LS-76

**Visit to Taber Metals to Inspect**

**APS Vacuum Chamber Extrusions**

Subject: Visit to Taber Metals to Inspect APS Vacuum Chamber Extrusions

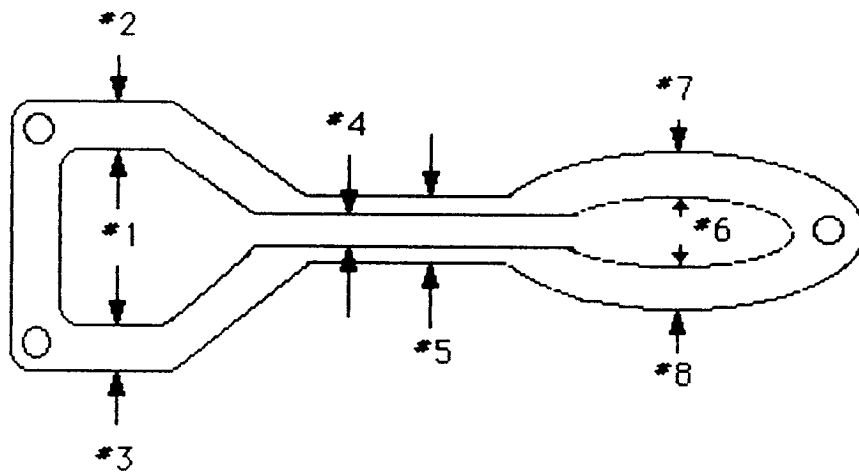
Several measurements were made on all seven extrusions and are listed on the following drawing and table :

From the above measurements one can see that the gap ( meas. #4) in the transition between the antechamber and beam chamber was considerably less than specified as was the height of the beam chamber opening (meas. # 6). A short ( 1 1/2 ) foot section of extrusion that had not been stretched was measured and found to be well within specifications. The stretching procedure is decreasing the height of these dimensions.

The next step is to modify the extrusion die such that the gap measurements will be oversize after extrusion but will decrease to the specified values during the stretching process. It is projected that this will be attempted during mid- December.
